#### Transitioning from RC210xxA (VersaClock) to RC2121xA (AutoClock)

This document describes how to design a PCB to support the transition from RC210xxA (RC21008A, RC21012A) VC7 devices to RC2121xA (RC21211A, RC21212A, RC21213A, RC21214A) AutoClock devices.

Figure 1. Pinout Differences between 48-VFQFPN RC210xxA and RC2121xA Devices

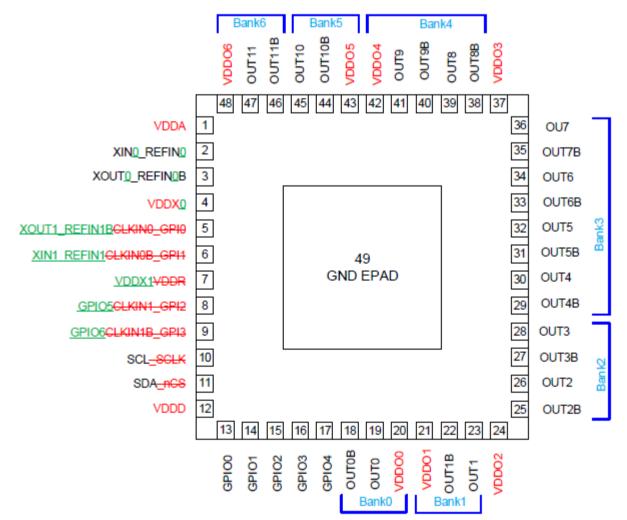
The RC210xxA VC7 and RC2121xA AutoClock are 48-pin VFQFPN devices with many pins in common. Figure 1 shows a mark-up of the device pin commonalities and differences between RC210xxA and RC2121xA.

- Black text: Common pins for both RC210xxA and RC2121xA devices
- Black with green text: Renamed pin for RC2121xA devices
- Red text with strikethrough: Previous pin name for RC210xxA devices
- Green text: New pin name for RC2121xA devices
- Red text: Renamed pin for RC2121xA devices
- Red with green text: Renamed pin for RC2121xA devices

Figure 2. Pinout Differences between 40-VFQFPN RC21008A and RC21213A/4A Devices

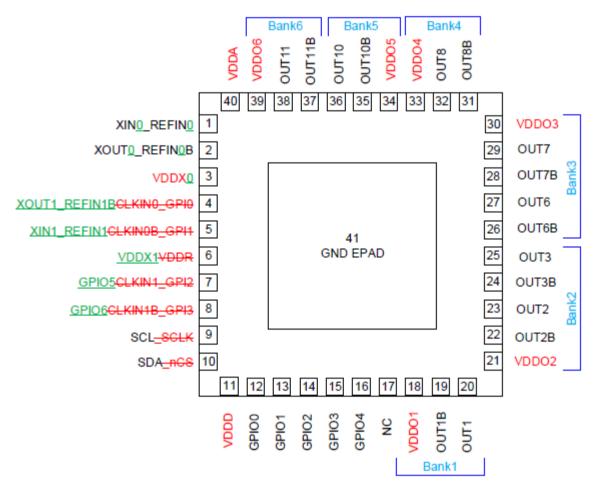
The RC21008A and RC21213A/4A are 40-pin VFQFPN devices with many pins in common. Figure 2 shows a mark-up of the device pin commonalities and differences between RC21008A and RC21213A/4A.

- Black text: Common pins for both RC21008A and RC21213A/4A devices
- Black with green text: Renamed pin for RC21213A/4A devices
- Red text with strikethrough: Previous pin name for RC21008A devices
- Green text: New pin name for RC21213A/4A devices
- Red text: Renamed pin for RC2121xA devices
- Red with green text: Renamed pin for RC21213A/4A devices
